# Access Compliance Report

## Public Rights-of-Way

Intersection ID: 5507	Main Street: GIBBON_RD	Cross Street: HORACE_MANN_RD	Location: SW
ADA ID: 5761EEAF66AC	Ramp Type: Perp	Initial Pass/Fail: Fail	Overall Compliance: No
		Severity Score: 12.5

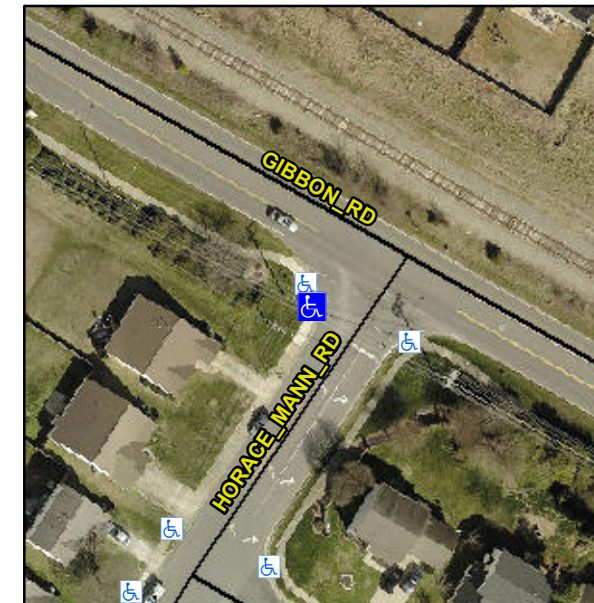
**Not Found, R304.2.2**

Compliance	Description	Data	Compliance	Description	Data
N/A	Ramp Length (in)	57.0	No	Ramp Slope (%)	9.1
Yes	Ramp Width (in)	48.0	Yes	Ramp XSlope (%)	1.3
N/A	Flare Type LT	N/A	N/A	Flare Type RT	N/A
N/A	Flare Slope LT (%)	N/A	N/A	Flare Slope RT (%)	N/A
N/A	Flare Traversable LT?	N/A	N/A	Flare Traversable RT?	N/A
N/A	Landing Length (in)	N/A	N/A	DWS Provided?	N/A
N/A	Landing Width (in)	N/A	N/A	DWS Contrast?	N/A
N/A	Landing Slope (%)	N/A	N/A	DWS Length (in)	N/A
N/A	Landing X Slope (%)	N/A	N/A	DWS Full Width?	N/A
N/A	Landing Curb? (Y/N)	N/A	N/A	DWS Offset (in)	N/A
N/A	Shared Landing?	N/A			
N/A	Gutter Ponding?	N/A	N/A	Gutter Slope (%)	N/A
N/A	Gutter Lip Ht (in)	N/A	N/A	Gutter X Slope (%)	N/A
N/A	Painted X Walk1?	No	N/A	Painted X Walk2?	N/A
	X Walk 1 Direction	To SE		X Walk 2 Direction	N/A
N/A	X Walk 1 Width (in)	N/A	N/A	X Walk 2 Width (in)	N/A
	X Walk 1 Slope (%)	1.3		X Walk 2 Slope (%)	N/A
	X Walk 1 X Slope (%)	0.9		X Walk 2 X Slope (%)	N/A

**Remove & Replace Entire Ramp.**
